INFORMATION BULLETIN NO. 110

TO: OWNERS OF J.H. FLETCHER & CO. MODEL DR AND CDR SINGLE MAST FEED ROOF DRILL ONLY

SUBJECT: MAST FEED CYLINDER GUARD

TITAN MAST GUARD

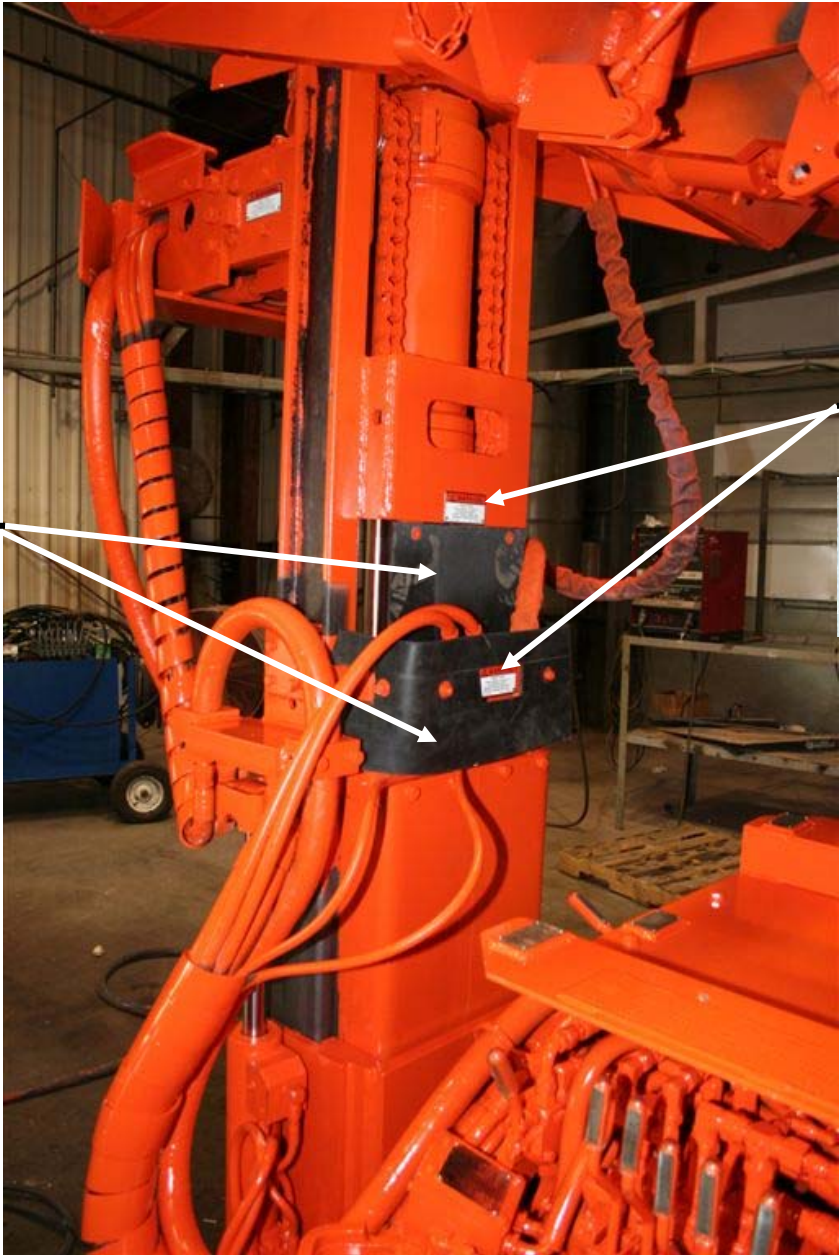
One specific place J.H. Fletcher & Co. is centering on in this bulletin is the pinch point between the inner and outer mast that is created when the drill mast moves up or down during the drilling and bolting process. Injury may occur, for instance, if the operator or a mechanic would place a hand on the outer section of the drill mast and activate the feed control handle prior to or without moving the hand from the drill mast. No body part should ever be positioned on any part of the mast or drilling mechanism.

The inner mast is designed to move up or down and to pass by the outer mast. If a finger, hand or body part is improperly located on the outer mast or in this pinch point, it can be caught and seriously damaged by the pinch point between these components.

To discourage someone from placing a hand or body part in this position, J.H. Fletcher & Co. is providing all owners of DR and CDR roof drills with a new mast guard arrangement for this area.

1. Install the new guard kit (PN 415666) on the rear of the mast area as a reminder to avoid and to discourage operators from placing any body part on or in this pinch point. The guard and two warning tags (PN 359078) are being provided free of charge and must be installed in place of all existing (previously installed) guards in this area (see Attachment 2).
